**Subject: Applicant's Responses to CEC Staff Data Requests 1-57
Los Esteros Critical Energy Facility, Phase 1 Relicense and Phase 2 Combined-
Cycle Conversion (03-AFC-02)**

**APPLICATION FOR CERTIFICATION
FOR THE LOS ESTEROS CRITICAL
ENERGY FACILITY PHASE 2
(LOS ESTEROS 2)**

DOCKET No. 03-AFC-2

Figure DR21-1
Los Esteros Critical Energy Facility
Nitrogen Deposition for Phase 2

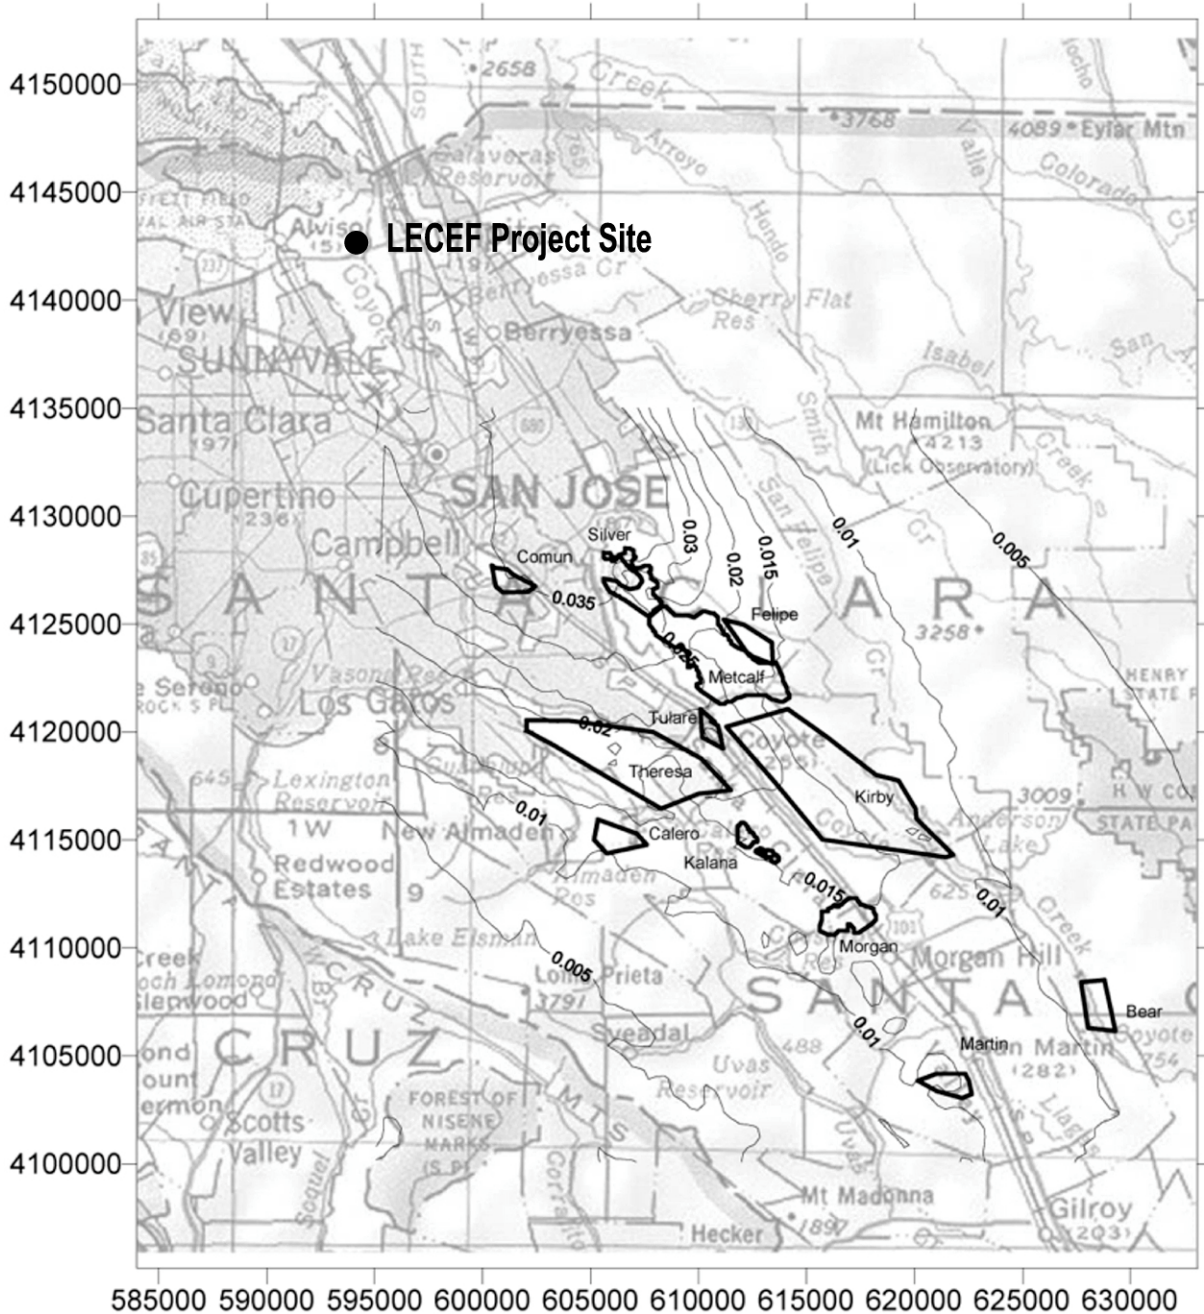
21. *If the nitrogen deposition modeling results for Phase 2 would be different than previous modeling, provide an analysis of the natural gas-fired combustion turbines in combined cycle configuration with the emissions of the fire pump using a USEFWS-approved model 1. The analysis should specify the amount of nitrogen deposition in the units kg/ha/year and the amount of deposition expected at potentially affected serpentine soils (such as Coyote Ridge and Tulare Hill). Provide an isopleth graphic over a USGS 7.5 minute quadrangle maps (or equally detailed map or more current map) of the direct deposition values (not weighted average). Identify on the maps the boundaries of the critical habitat for Bay checkerspot butterfly (Federal Register, April 30, 2001).*

Response: The Phase 2 nitrogen deposition analysis has been prepared based on the CEC-preferred ISCST3 model (version 02035). Model assumptions were identical to those used in the previous analysis approved by the Commission during the original Phase 1 licensing, with the following changes:

The requested isopleth for the Phase 2 Analysis is included as Figure DR21-1 (Attachment BIO-3).
